ACCESSIBILITY ASSESSMENT

ADA TITLE II ASSESSMENT

Central Gardens
6804 Central Avenue
Pepper Mill Village, Maryland 20743

June 23, 2021

Map for Barrier ID: AX239621

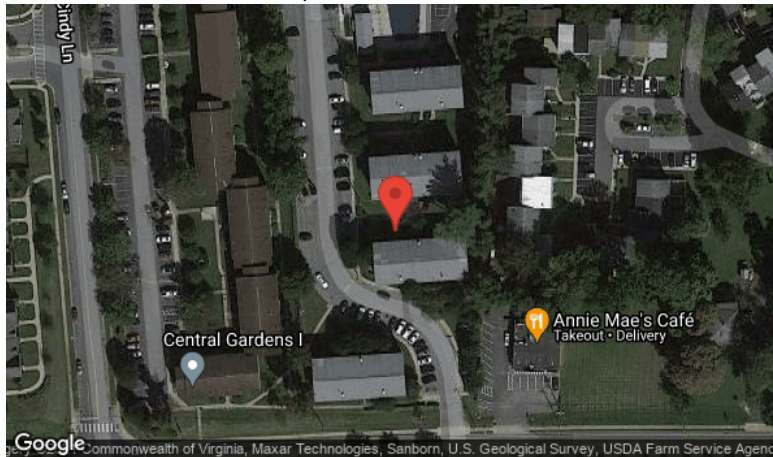
Barrier Detail

The accessible route should be graded to a maximum 1:20 (5%) running slope and 1:50 (2%) cross slope. An accessible route has maximum 1:20 (5%) running slope, maximum 1:50 (2%) cross slope. [EXCEPTION: Cross slopes not greater than 1:48 (2.08%) are permitted.] Where grading to maximum running slope of 1:20 (5% running slope) is not possible, provide a compliant ramped surface within the walkway with maximum slope 1:12 (8.33%) and maximum ramp run rise of 6" without handrails. If a ramped surface with running slopes greater than 1:20 (5%) and maximum 1:12 (8.33%) rises more than 6", handrails are required. An accessible route has a minimum clear width 36". [EXCEPTION: The clear width shall be permitted to be reduced to 32" minimum for a length of 24" maximum provided that reduced width segments are separated by segments that are 48" long minimum and 36" wide minimum.] The cost estimate for this barrier removal is based on grading the running slope to maximum 1:20 (5%). The quantity and order of magnitude cost estimate provided for this barrier are limited to the extent of the area identified as non-compliant. Additional costs that may be associated with removal of the barrier are not included.

Map for Barrier ID: AX239622

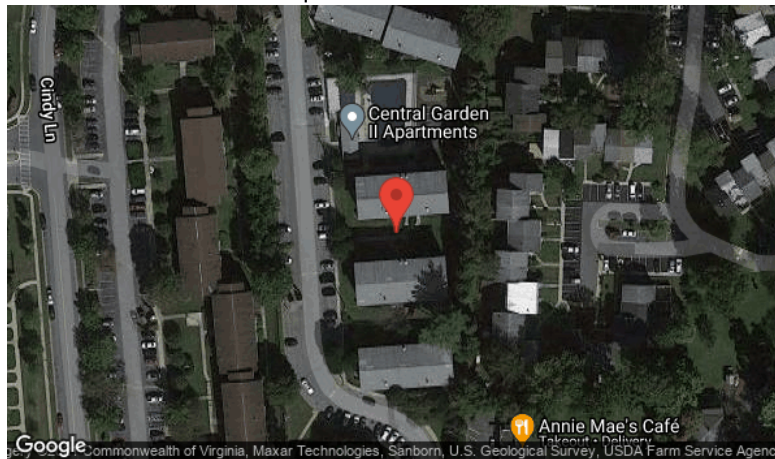
Assembly	Exterior Access Route
Type	Exterior Accessible Route
ADA Standard	403.3
Barrier Detail	The accessible route has cross slopes greater than 1:50 (2%).
Location Description	From Parking to Building 6806
Observed	May 28, 2021 by Lloyd.fojas@bureauveritas.com
Site Conditions	The accessible route has a cross slope of 3.6%.

The walkway should be graded to a maximum 1:50 (2%) cross slope. An accessible route has maximum 1:20 (5%) running slope and maximum 1:50 (2%) cross slope. [EXCEPTION: Cross slopes not exceeding 1:48 (2.08%) are permitted.] The clear width of walking surfaces shall be 36" minimum. [EXCEPTION: The clear width shall be permitted to be reduced to 32" minimum for a length of 24" maximum provided that reduced width segments are separated by segments that are 48" long minimum and 36" wide minimum.] Where grading to maximum running slope of 1:20 (5% running slope) is not possible, provide a compliant ramped surface within the walkway with maximum slope 1:12 (8.33%) and maximum ramp run rise of 6" without handrails. If a ramped surface with running slopes greater than 1:20 (5%) and maximum 1:12 (8.33%) rises more than 6", handrails are required. The cost estimate for this barrier removal is based on grading the running slope to maximum 1:20 (5%). The quantity and order of magnitude cost estimate provided for this barrier are limited to the extent of the area identified as non-compliant. Additional costs that may be associated with removal of the barrier are not included.

Map for Barrier ID: AX239618

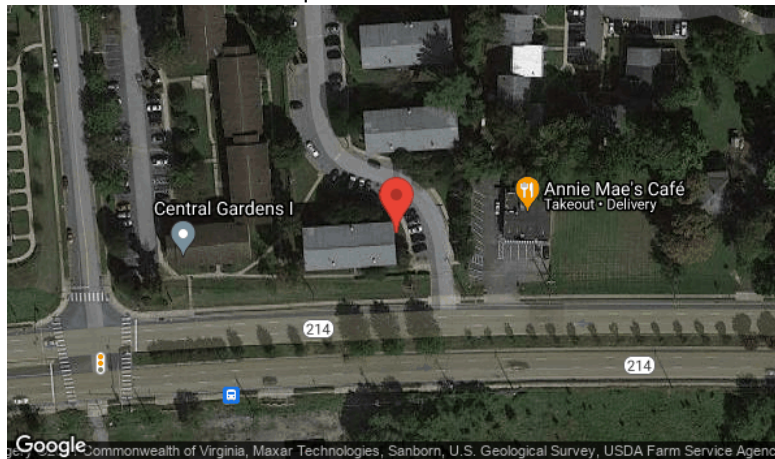
Assembly	Exterior Access Route
Type	Exterior Accessible Route
ADA Standard	403.3
Barrier Detail	The accessible route has running slopes greater than 1:20 (5%).
Location Description	Near Building 6804
Observed	May 28, 2021 by Lloyd.fojas@bureauveritas.com
Site Conditions	The accessible route has a running slope of 7.7%.

Grade the accessible route to maximum 1:20 (5%) running slope. An accessible route has maximum 1:20 (5%) running slope, maximum 1:50 (2%) cross slope, and minimum clear width 36". [EXCEPTION: Cross slopes not greater than 1:48 (2.08%) are permitted.] Where grading to maximum running slope of 1:20 (5% running slope) is not possible, provide a compliant ramped surface within the walkway with maximum slope 1:12 (8.33%) and maximum ramp run rise of 6" without handrails. If a ramped surface with running slopes greater than 1:20 (5%) and maximum 1:12 (8.33%) rises more than 6", handrails are required. A compliant ramp has maximum 1:12 (8.33%) running slope, maximum ramp run rise 30", landings at the top and bottom of ramp runs, handrails where the ramp run rise is greater than 6", and edge protection with exceptions. The cost estimate for this barrier removal is based on grading the running slope to maximum 1:20 (5%). The quantity and order of magnitude cost estimate provided for this barrier are limited to the extent of the area identified as non-compliant. Additional costs that may be associated with removal of the barrier are not included.
